## Notice of Allowability

10/015,848

### EXAMINER'S AMENDMENT

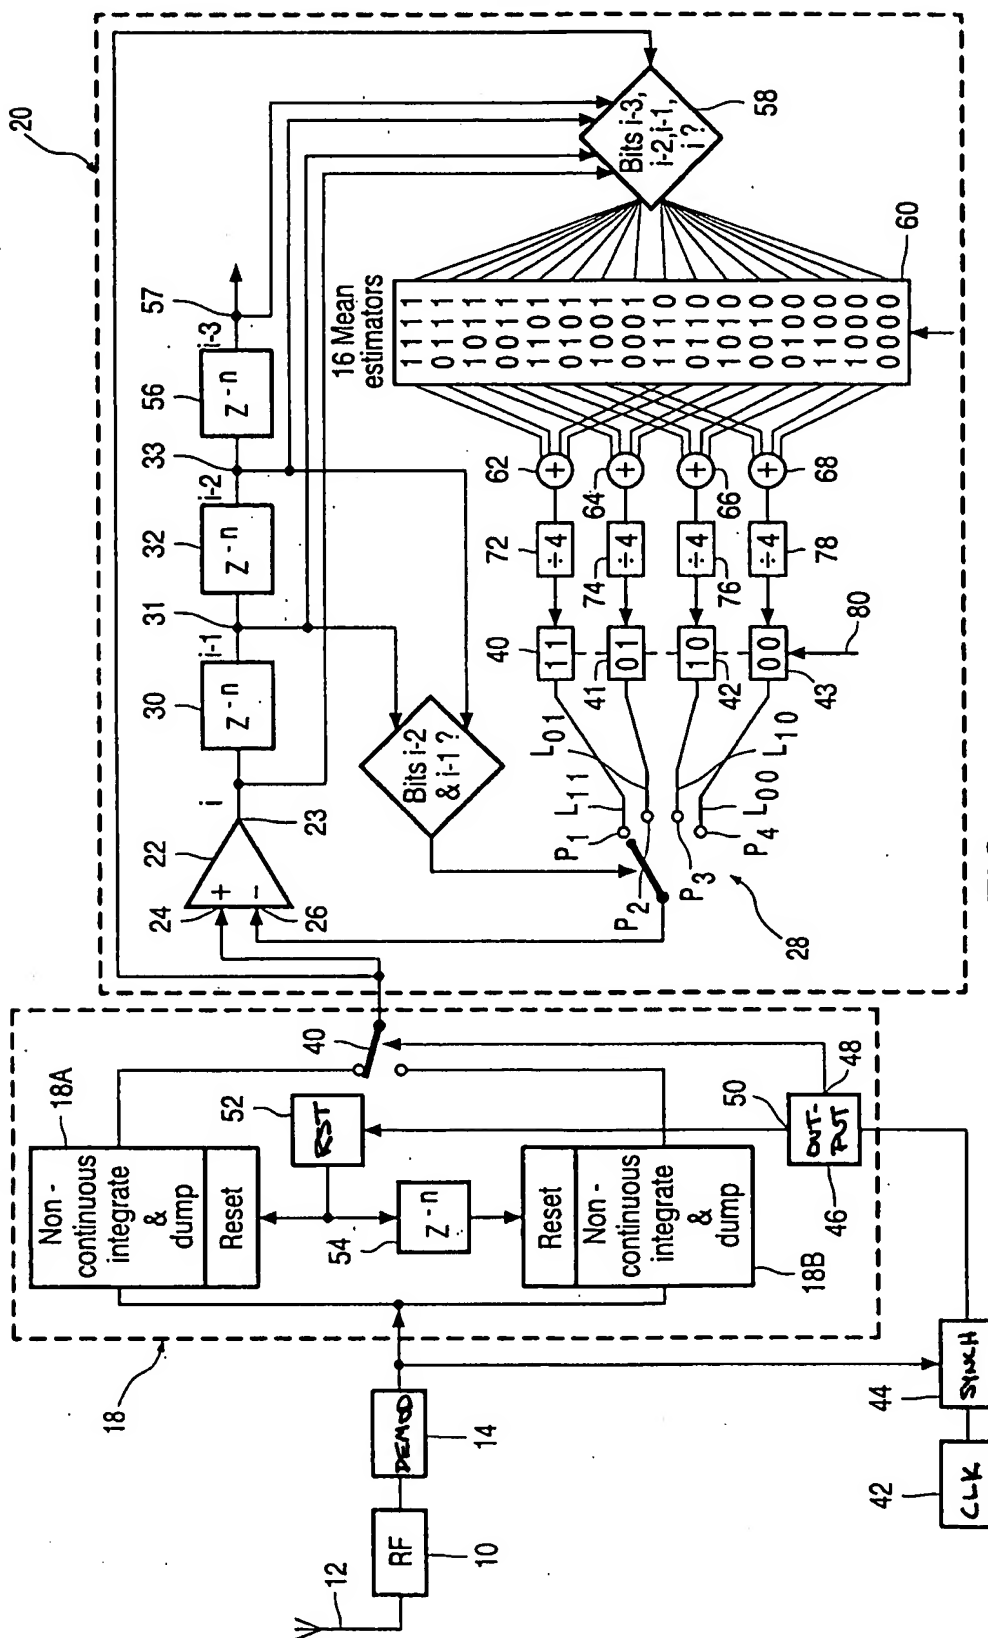
3. The following changes to the drawings have been approved by the examiner and agreed upon by applicant:

- a. Clean drawing sheets (3/6, fig. 4 and 6/6, fig. 7) submitted July 6, 2005 having every reference block labeled as attached.

In order to avoid abandonment of the application, applicant must make these above agreed upon drawing changes.
